**TOWN OF SURFSIDE
PLANNING AND ZONING BOARD
AND
DESIGN REVIEW BOARD MEETING**

**JULY 30, 2015
7:00 PM**

MEMORANDUM

To: Design Review Board
Thru: Guillermo Olmedillo, Town Manager
From: Sarah Sinatra Gould, AICP, Town Planner
CC: Linda Miller, Town Attorney
Date: June 25, 2015
Re: 9525 Carlyle Avenue

To: Design Review Board
 Thru: Guillermo Olmedillo, Town Manager
 From: Sarah Sinatra Gould, AICP, Town Planner
 CC: Linda Miller, Town Attorney
 Date: June 25, 2015
 Re: 9540 Harding Avenue

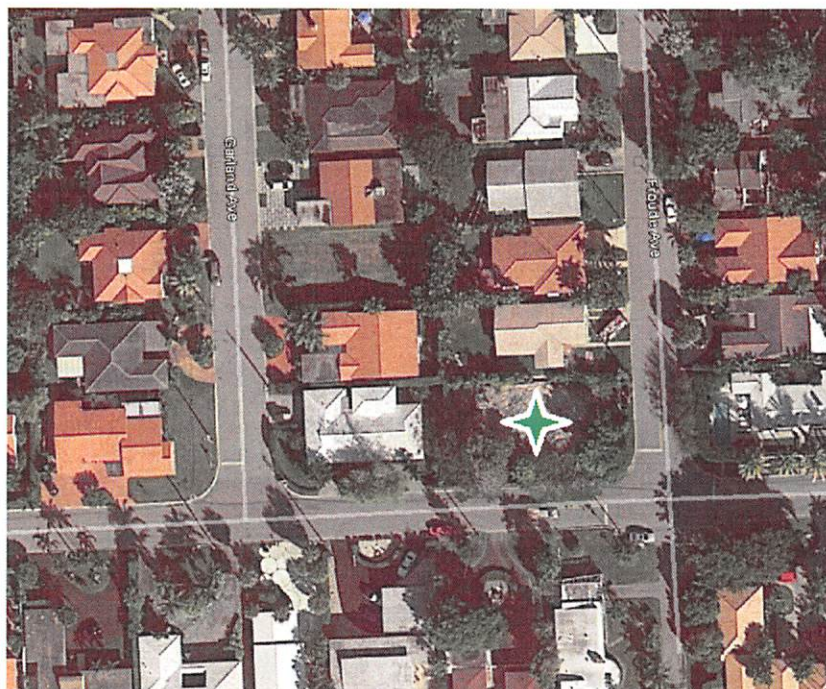
Staff recommends approval with the condition of approval that the façade behind the sign is repaired and repainted.

To: Design Review Board
 Thru: Guillermo Olmedillo, Town Manager
 From: Sarah Sinatra Gould, AICP, Town Planner
 CC: Linda Miller, Town Attorney
 Date: June 25, 2015
 Re: 901 88th Street, New Residence

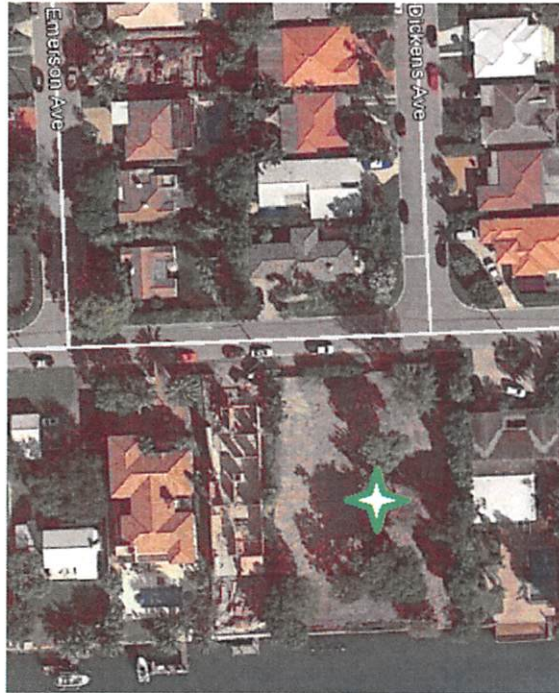
Required	Proposed
Roof types and slopes should be generally the same over all parts of a single building.	Consistent
Restricted materials for roofs are pre-determined in the Town's Building Code, which restricts roofing materials to: 1. Clay tile; 2. White concrete tile; 3. Solid color cement tile which color is impregnated with the same color intensity throughout, provided said color is first approved by the planning and zoning board; and 4. Metal.	A tile roof is proposed.

Required	Proposed
Window styles should always be consistent among all elevations of a building.	Consistent.
Frame materials should never vary on a single building.	No variation.
Window, door and eave trim should be consistent on all elevations of the house	Consistent.

Staff recommends approval.

To: Design Review Board
 Thru: Guillermo Olmedillo, Town Manager
 From: Sarah Sinatra Gould, AICP, Town Planner
 CC: Linda Miller, Town Attorney
 Date: June 25, 2015
 Re: 9181 Abbott Avenue, New Residence

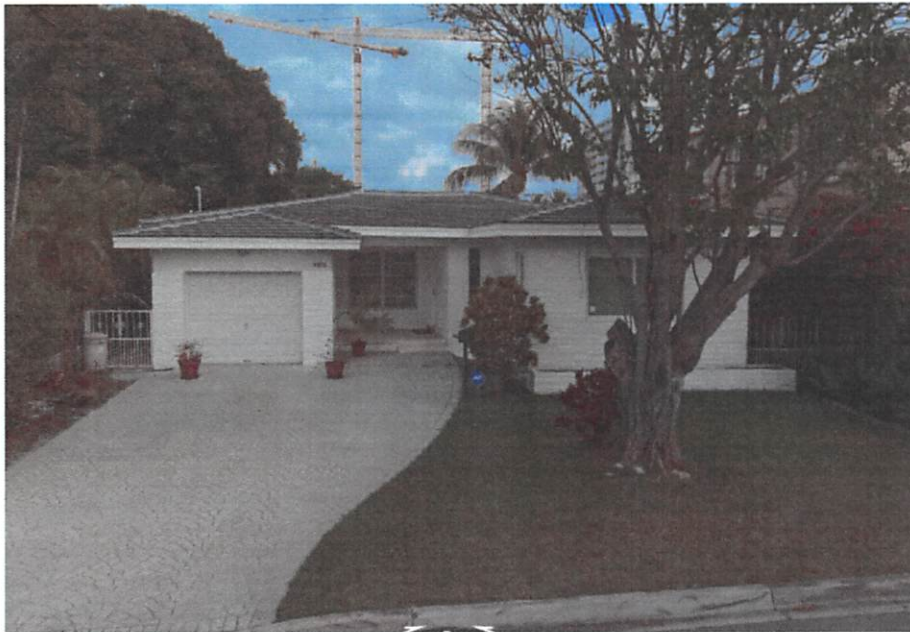
The property is located at 9181 Abbott Avenue, within the H30B zoning. The applicant is proposing the construction of a new two story single-family residence. This was previously reviewed by the Design Review Board on January 29, 2015, however the applicant is requesting modifications to the approved design.

Required	Proposed
Roof types and slopes should be generally the same over all parts of a single building.	Consistent
Restricted materials for roofs are pre-determined in the Town's Building Code, which restricts roofing materials to: 1. Clay tile; 2. White concrete tile; 3. Solid color cement tile which color is impregnated with the same color intensity throughout, provided said color is first approved by the planning and zoning board; and 4. Metal.	Standing seam metal roof.

Staff recommends approval.

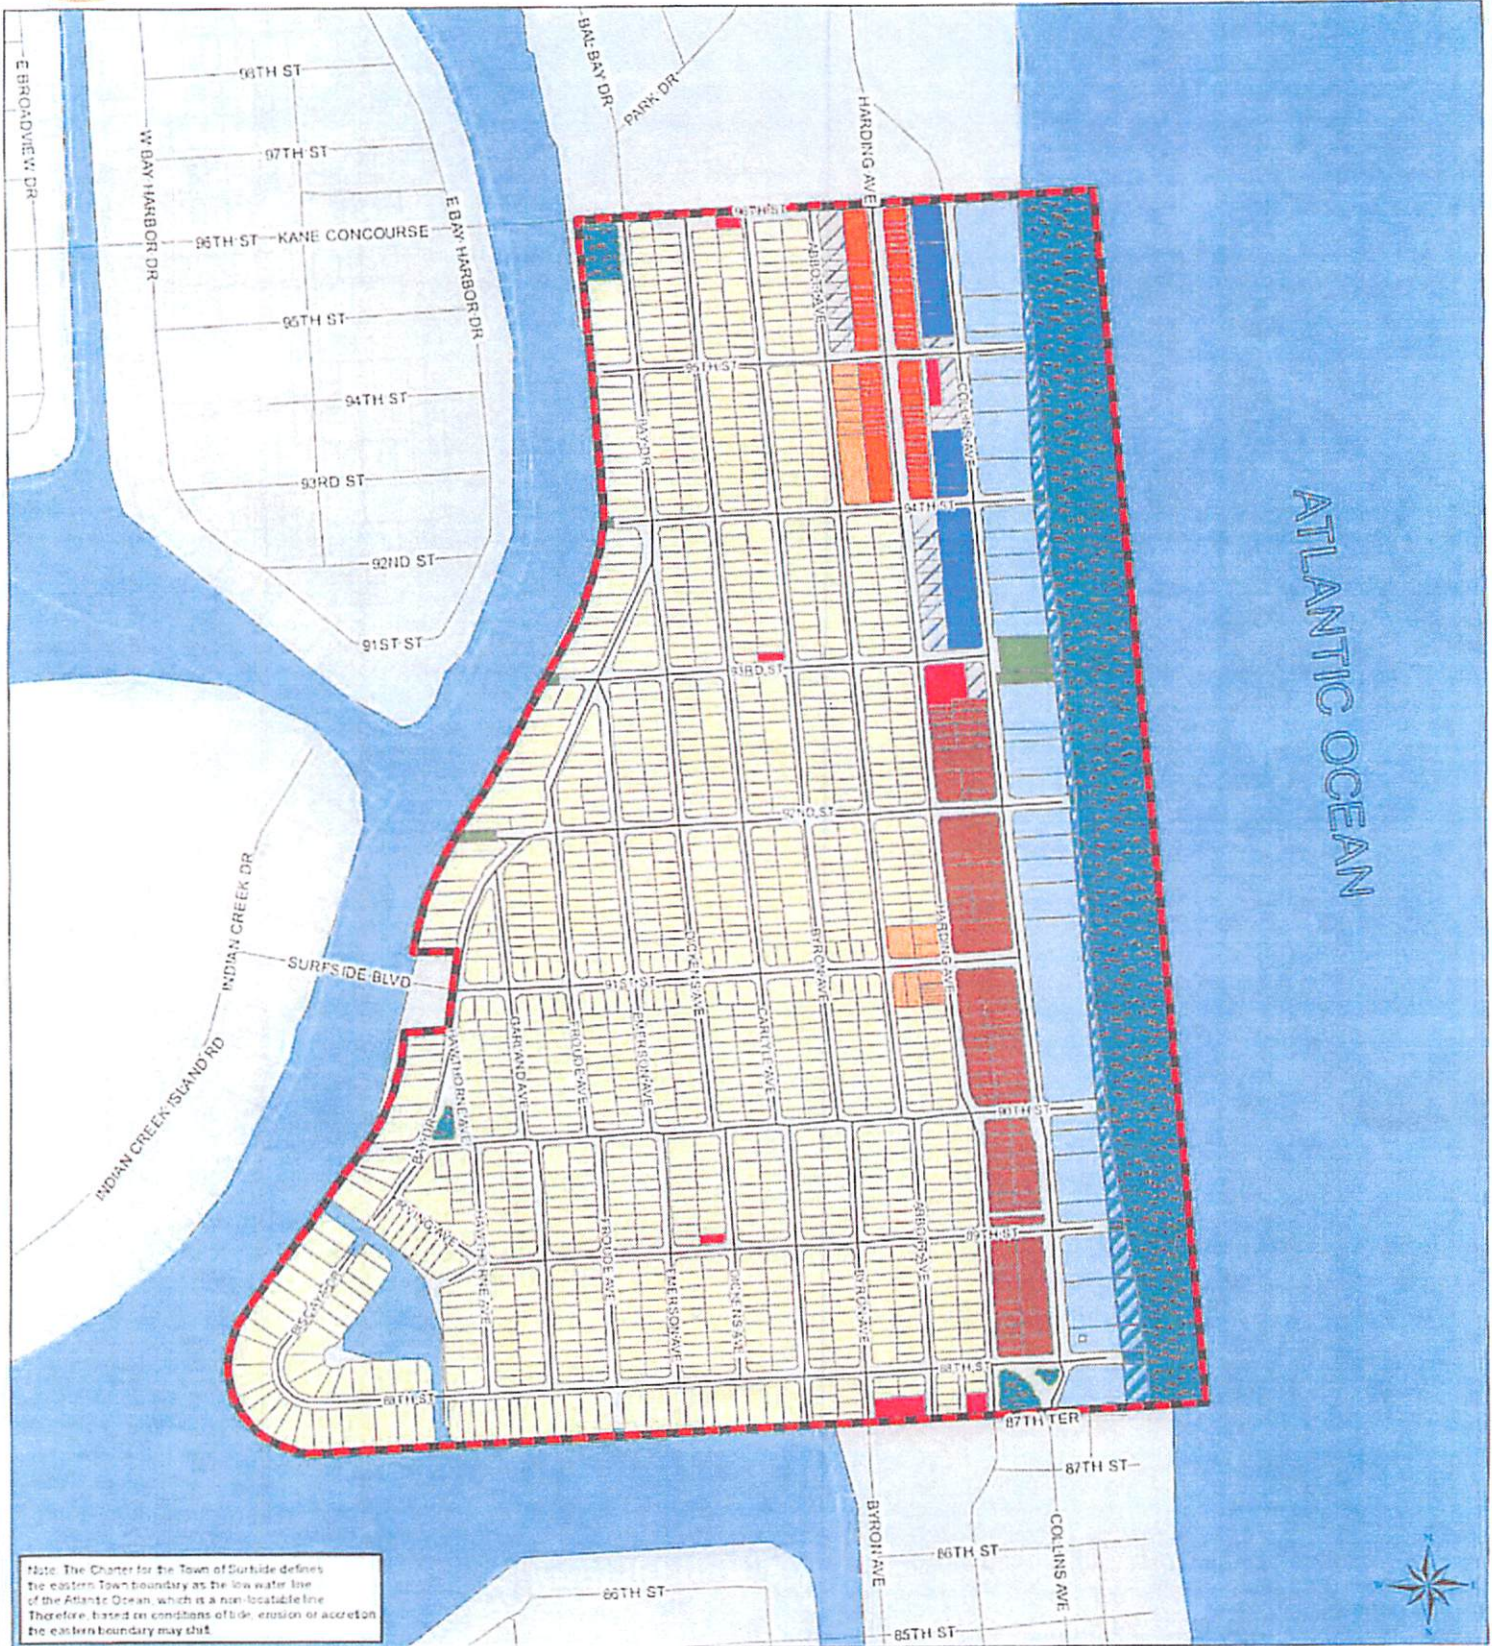
- (1) ~~H30C: Shall not exceed 270 feet.~~ For every 50 feet, a minimum three-foot change in wall plane.
- (2) ~~H40: Shall not exceed 270 feet.~~ For every seventy-five (75) feet, a minimum six-foot change in wall plane.
- (3) ~~H120: Shall be limited to a~~ For every 100 feet, a minimum six-foot change in wall planes. ~~The change shall be either vertical or horizontal. The maximum of 270 feet of continuous wall frontage in is limited to a~~ building platform no greater than 30 feet in height. This platform may

a) A tower above the platform shall provide a continuous wall plane no greater than 150 feet in length with a minimum six-foot vertical or horizontal change in wall plane.

RECOMMENDATION: Town Commission approve the attached Ordinance amending Section 90-51.1 to provide further limitations on the maximum continuous wall frontage.

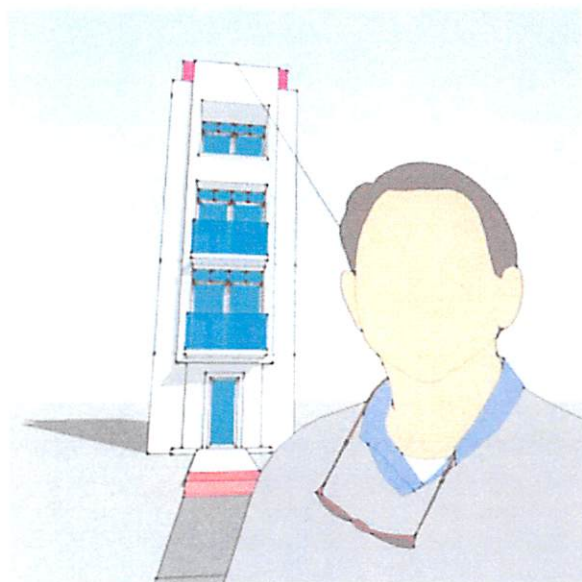
- Require additional articulations for facades facing Collins Avenue and Harding Avenue. (demonstrated below)

- Provide a facade articulation of a minimum of 2-Feet every 25 Feet
- a minimum of 30% of the cumulative facade's area with a primary frontage shall be recessed back a minimum of 5-Feet, provided each recessed area does not exceed 500 square feet
- When more than 1 building is provided, buildings shall be designed in such a way that more than 30% of the facades are volumetrically dissimilar
